LETTER OF TRANSMITTAL

DATE: 04/09/2004
PROJECT NO.: 36-93244-003-2051
PROJECT: White Tail Addition Min. Pad Elevation

CERTIFICATE OF CORRECTION TO WHITE TAIL

AFFIDAVIT

LOT 54, BLOCK 1
WHITE TOWN

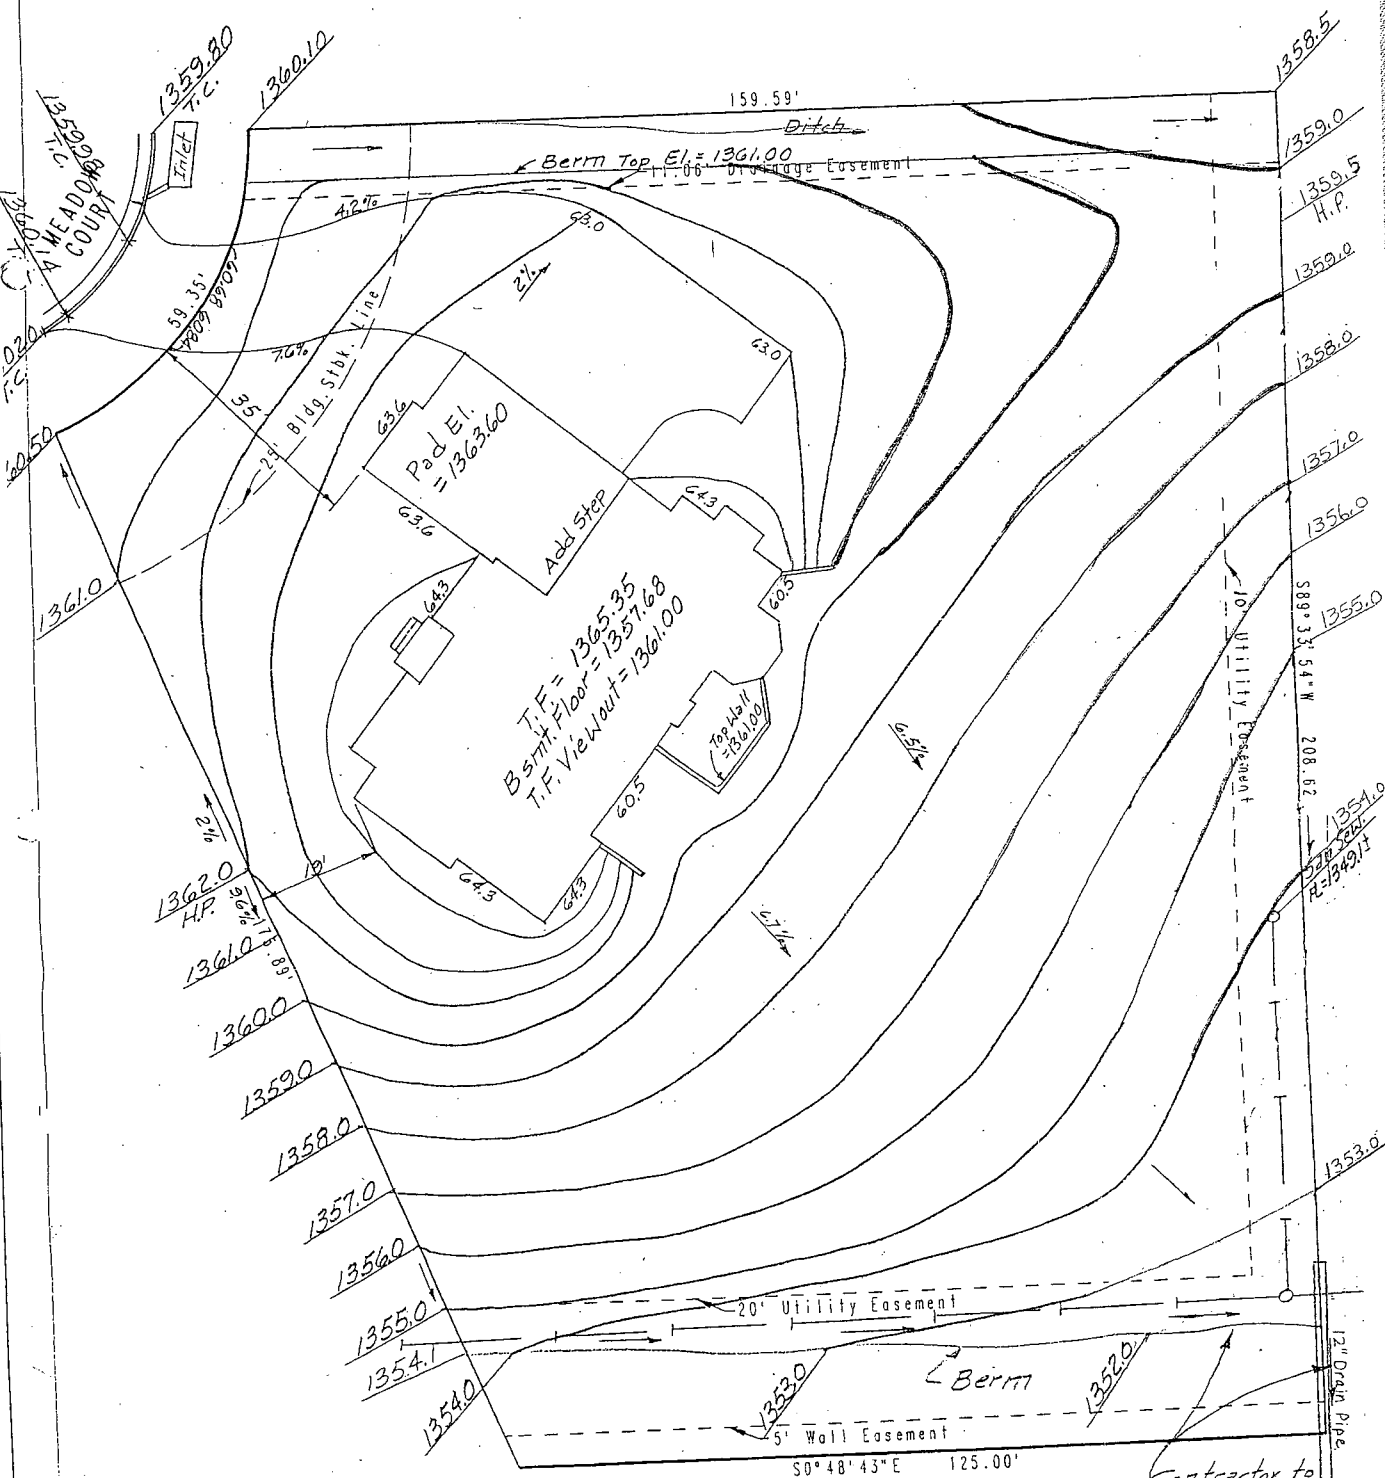
We, Professional Engineering Consultants, P.A., Engineers and Surveyors in aforesaid State and County have found that the minimum pad elevation (lowest opening) for that portion of Lot 54, Block 1, White Tail Addition, described as beginning at the Northwest corner of Lot 54, Block 1, White Tail Addition; thence bearing N89°33'54"E along the North line of said Lot 54, a distance of 208.62 feet to the Northeast corner of said Lot 54; thence bearing S00°48'43"E, a distance of 125.00 feet to the Southeast corner of said Lot 54; thence bearing N85°46'49"W a distance of 88.30 feet; thence bearing N53°10'20"W, a distance of 65.92 feet; thence bearing N41°57'07"W, a distance of 104.07 feet to the Northwest corner of said Lot 54 and the Point of Beginning, should be changed to elevation 1357.5 M.S.L.

3. The undersigned has examined said recorded subdivision plat of WHITE TAIL, an addition to Sedgwick County, Kansas, and found that the minimum pad elevation (lowest opening), requirement for said portion of Lot 54, Block 1, as described in Exhibit A, should be changed to 1357.5 M.S.L.

Minimum Pad Elev. (Lowest Opening) = 1360.0 m.s.l.
